**Appendix C- Elephant & Castle to Crystal Palace Quietway (QW7)
New Church Road / Edmund Street junction to Dog Kennel Hill**

Main Consultation Issues and Responses

Detailed Consultation Comments and Responses

Consultation Area

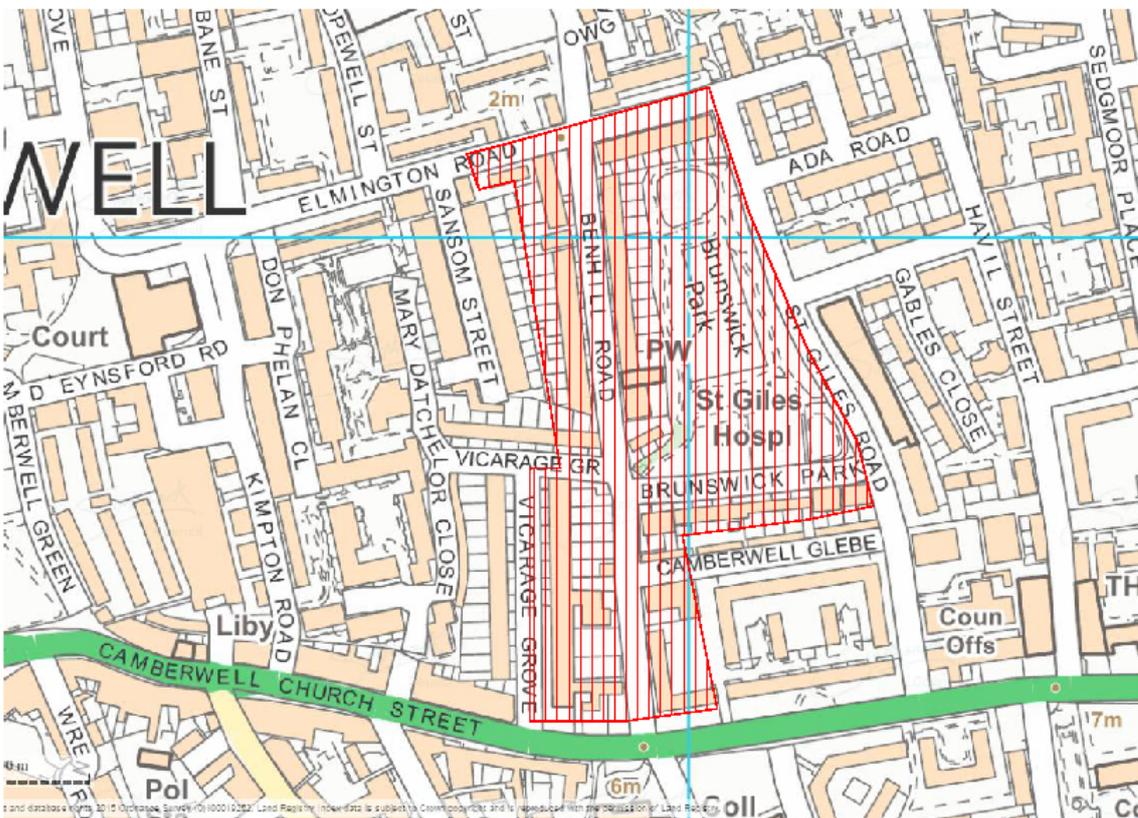
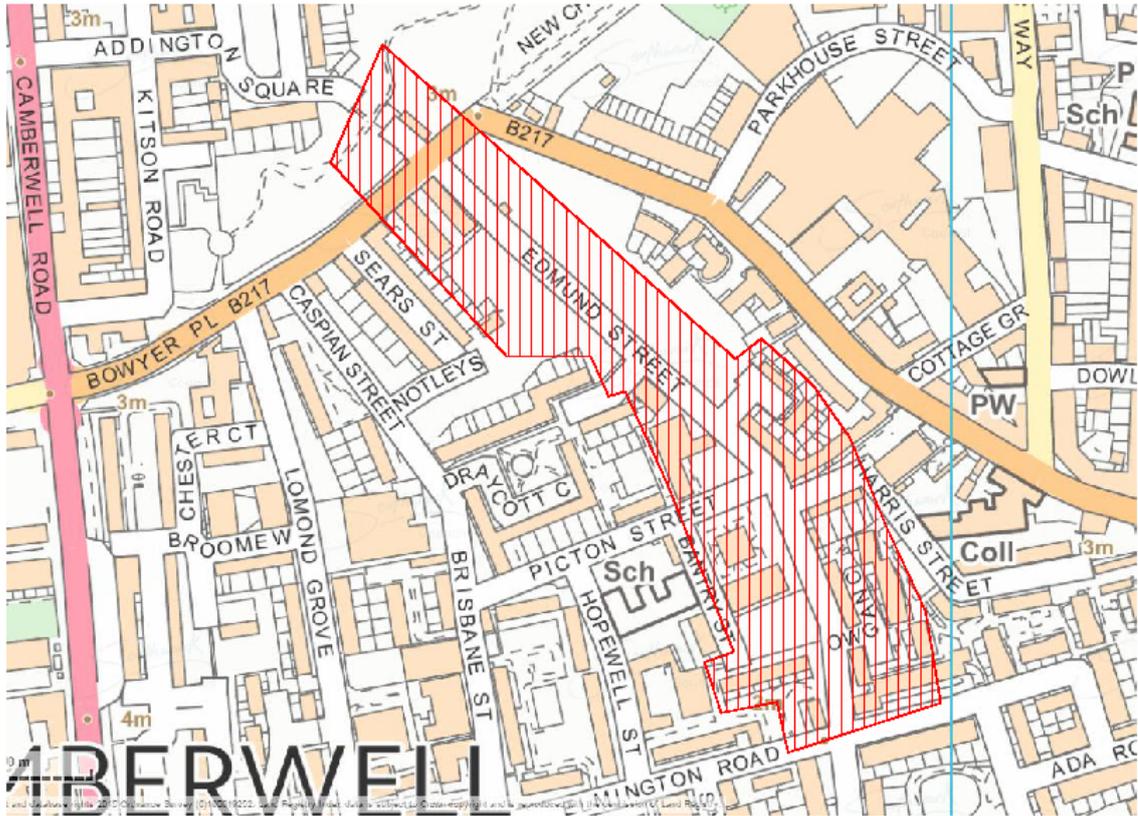
New Church Road / Edmund Street junction to Peckham Road		
Proposal	Concern/Objection	Response
Overall	New Church Road / Edmund Street / Southampton Way Junction is unsafe for pedestrians and cyclists trying to cross	Further investigation and analysis of this junction will be carried out and proposals to improve road safety and pedestrian accessibility will be considered during preliminary design stage.
	Request for modal filtering - Speeding and rat-running along Edmund Street / Church Street will not be discouraged with current proposals.	LBS is currently investigating point closure options on Edmund Street and Benhill Road. Traffic re-assignment analysis is being carried out to assess the impact of closures.
Extension of double yellow lines	Loss of parking.	The extension of double yellow lines aims at improving visibility at or near junctions to reduce the likelihood of accidents occurring. It is part of LBS strategy to increase the safety for all road users as it addresses the conflicts because vehicles as well as vehicles and pedal cycles.

Proposals at Brunswick Park / Benhill Road junction	Adequate visibility is achieved with current junction layout.	Large radius layout raises the likelihood of left turn collision at junction. Visibility is improved with proposed layout.

**Consultation Area
Wilson Road to Lettsom Street**

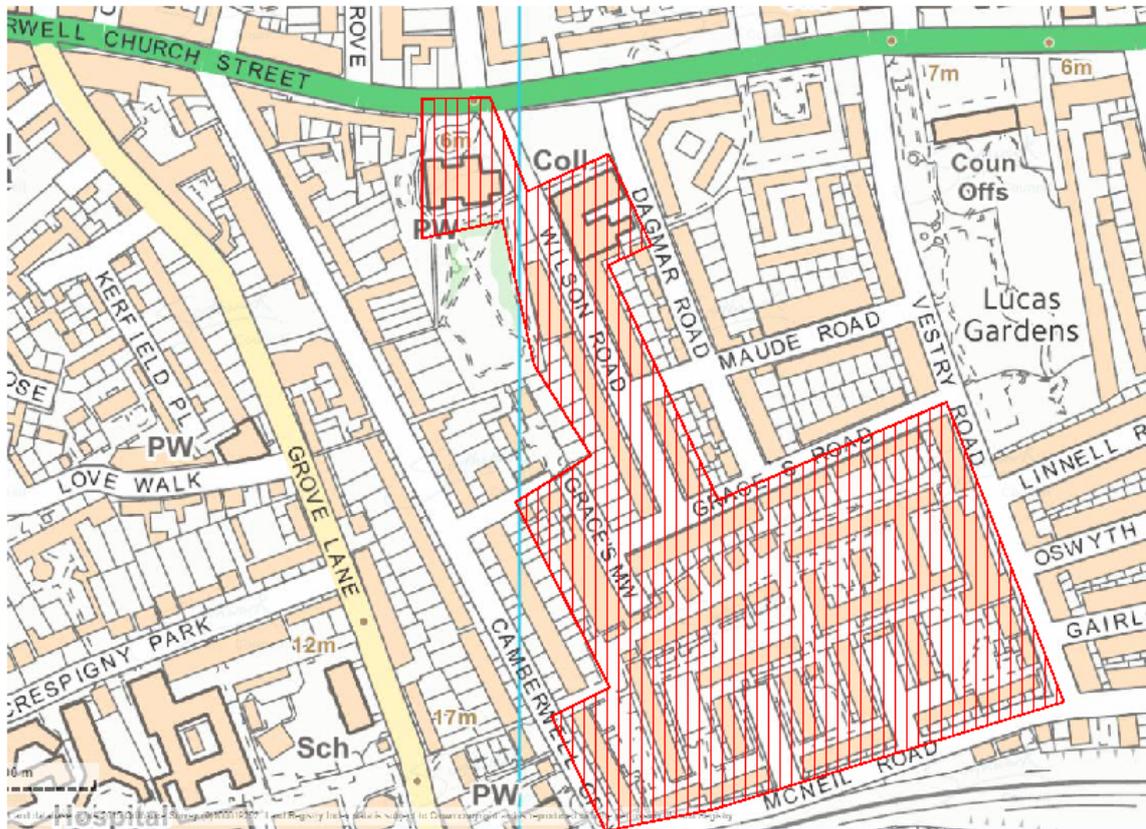
Wilson Road to Lettsom Street		
Proposal	Concern/Objection	Response
Overall	Inadequate provision for cyclists at Peckham Road / Wilson Road / Benhill Road junction.	The signal timings on South alignment of Peckham Road/Benhill Road are appropriate to operate safe QW. As this junction is part of the TLRN, any concerns related to cyclist and pedestrian safety will be raised with TfL.
	Lack of proposals on Camberwell Grove	Further traffic re-assignment analysis is currently being carried out to investigate measures to reduce the number of motor vehicles using Camberwell Grove as a through route. Measures for Camberwell Grove are also being considered.
Extension of double yellow lines	Loss of parking.	The extension of double yellow lines aims at improving visibility at or near junctions to reduce the likelihood of accidents occurring. It is part of LBS strategy to increase safety for all road users as it addresses the conflicts between vehicles as well as between vehicles and cyclists.

Conversion of existing stepped access at Grace's Mews to ramp	Conflict between pedestrians and cyclists	Segregation between pedestrians and cyclists will be provided along the ramp. Additional signing will be considered in detailed design.
	Insufficient lighting at this location.	A street lighting assessment will be undertaken along the whole route as part of this scheme. The introduction of the pathway linking Grace's Mews with Lettsom Street will require a lighting upgrade at this location, as already proposed in the consultation material.

Dog Kennel Hill / Champion Hill-Consultation Plan

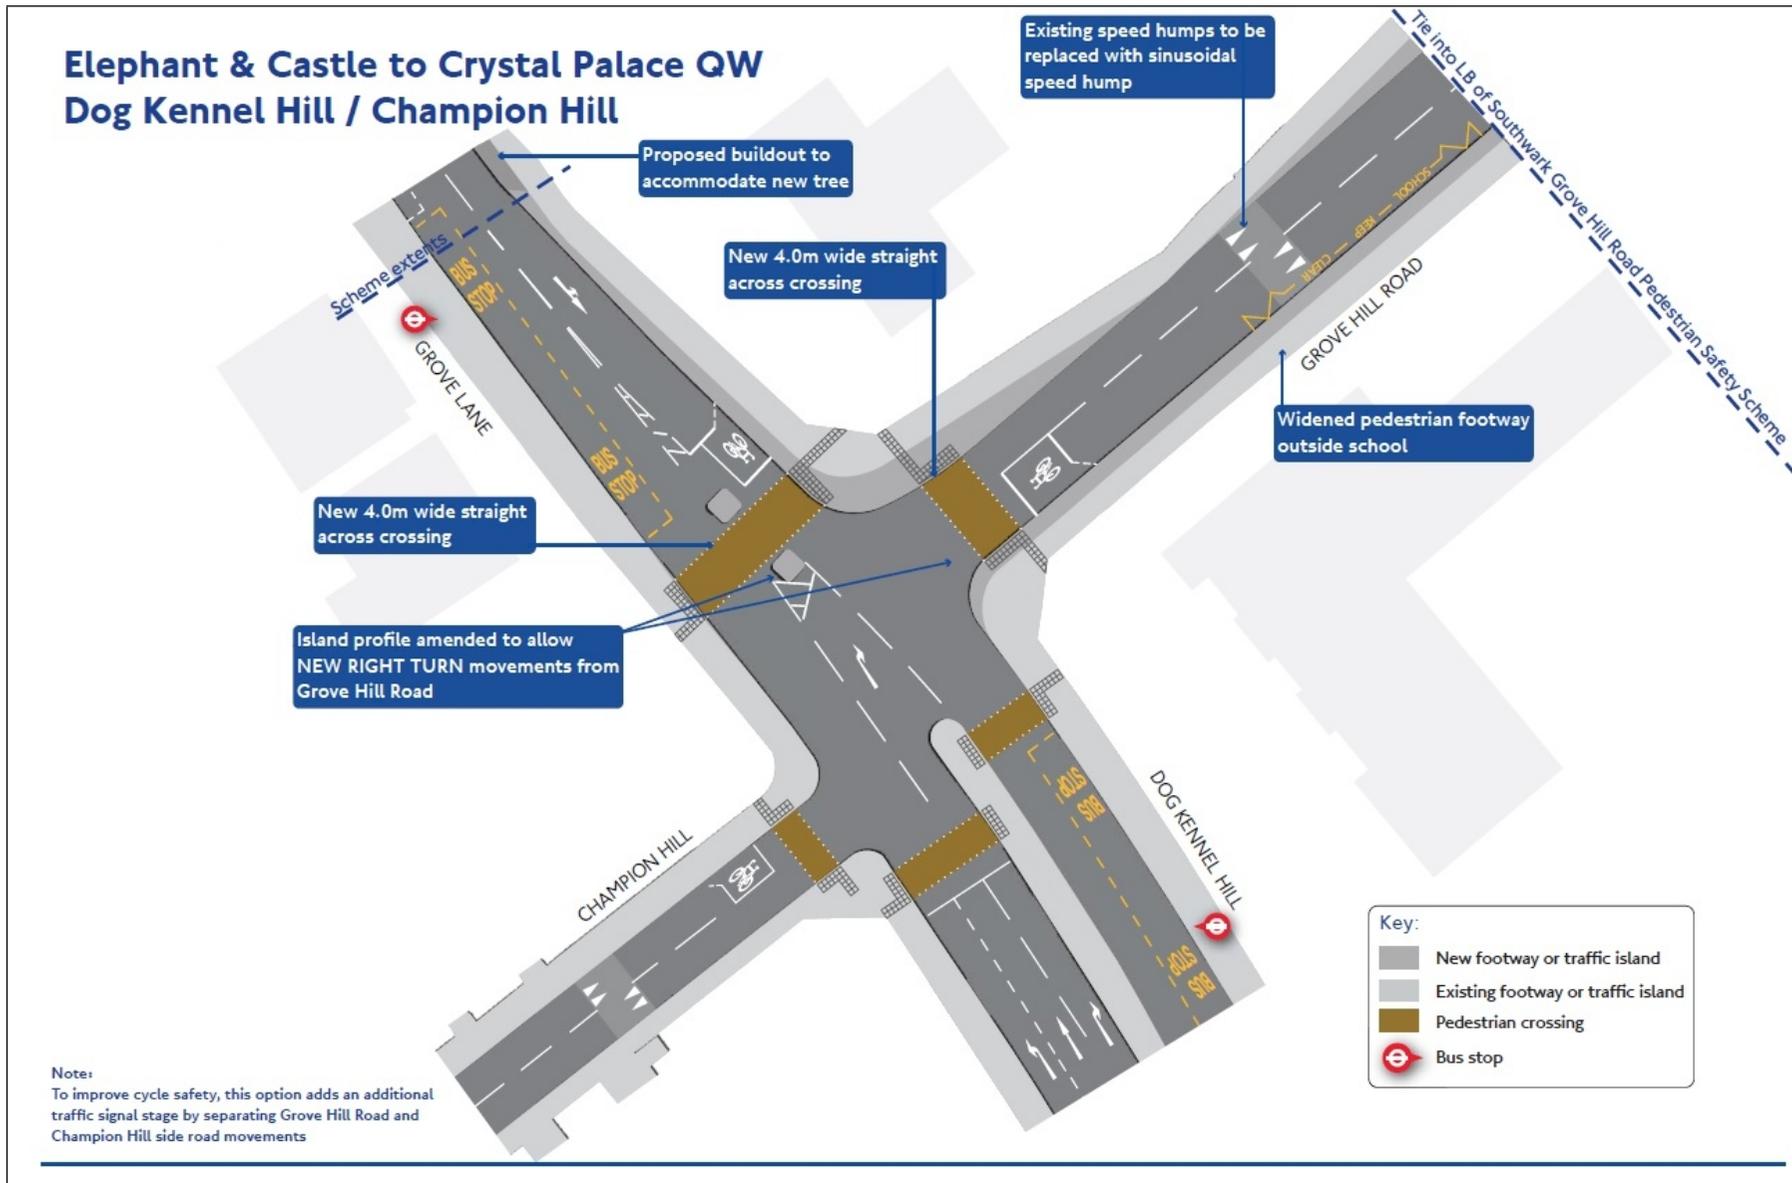
Dog Kennel Hill / Champion Hill		
Proposal	Concern/Objection	Response
Overall Scheme Comments	Rat-running on Camberwell Grove to Dog Kennel Hill	Further traffic re-assignment analysis is currently being carried out to investigate measures to reduce the attractiveness of this route to motor vehicles passing through the area.
	Unsafe layout for cyclists turning right from Peckham Road into Camberwell Grove	No measures are currently proposed to this junction, however, consideration will be given to improvements should a suitable funding stream become available.
	Suggested introducing traffic calming measures on Camberwell Grove	Further traffic re-assignment analysis is currently being carried out to investigate measures to reduce the attractiveness of this route to motor vehicles passing through the area. Measures for Camberwell Grove are also being considered.
The introduction of the right turn from Grove Hill Road into Grove Lane	Concerned increasing volume of traffic due to recent changes of Camberwell Grove/Grove Hill.	There is potential for an increase in traffic volumes at this junction due to the provision of an additional manoeuvre at this junction.

Champion Hill and Grove Hill operating in different signal phases to improve road safety	Objection to different signal phases due to existing delays at the junction at peak times	Increase in delays at this junction will be considered carefully against improvements at the junction.
Improve safety	Objection to replacing the existing speed bumps with	Sinusoidal speed humps are proposed to provide greater

for pedestrians	sinusoidal humps	comfort for cyclists.
	Objection to widening pedestrian footway due to narrow road for motorists	Increase in delays at this junction will be considered carefully against improvements at the junction.
